# UNITED STATES PATENT AND TRADEMARK OFFICE

APPLICATION NO.	FILING DATE	FIRST NAMED INVENTOR	ATTORNEY DOCKET NO.	CONFIRMATION NO.
10/790,230	03/02/2004	Gansha Wu	42339-193222	9836
26694	7590	08/21/2006	EXAMINER	
VENABLE LLP P.O. BOX 34385 WASHINGTON, DC 20045-9998			LEWIS, CHERYL RENE A	
			ART UNIT	PAPER NUMBER
			2167

## Office Action Summary

FIG. 1

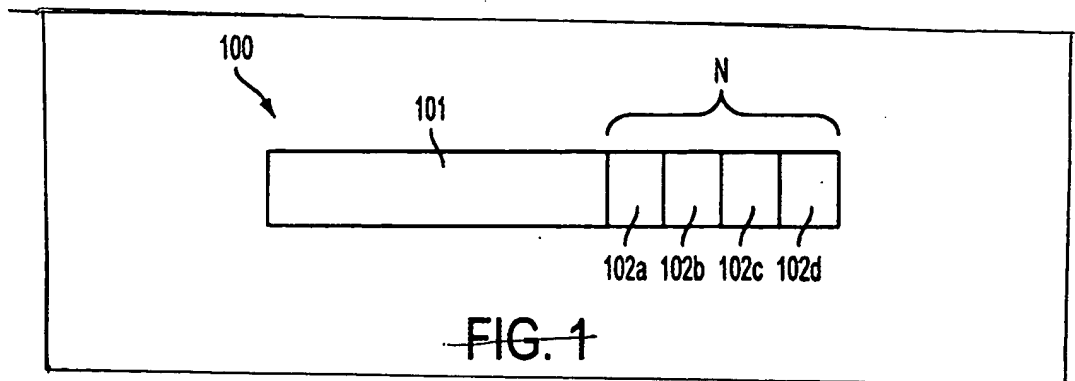
2. The drawings are objected to because drawing figures 1, 2, and 4-7 depict a partial view of the drawing figures. A box and/or a line drawn around each individual drawing figure is needed to show each individual figure as a separate entity (MPEP 37 CFR 1.84(h)).

3. The drawings are objected to under 37 CFR 1.83(a). The drawings must show every feature of the invention specified in the claims. Therefore, the "K-bit" must be shown or the feature(s) canceled from the claim(s). No new matter should be entered.

The "N" variable is identified in the drawings of figure 1 and in the Specification. In the Specification, page 5, paragraph 00019, the "N" variable is identified as a number of bits. However, the applicants have failed to identify the "K-bit", particularly the "K" variable has not been identified.

As a convenience to the applicants, the examiner has attached an amendment of drawing figures 1, 2, and 4-7 to show by example, how to effectively amend drawing figures 1, 2, and 4-7.
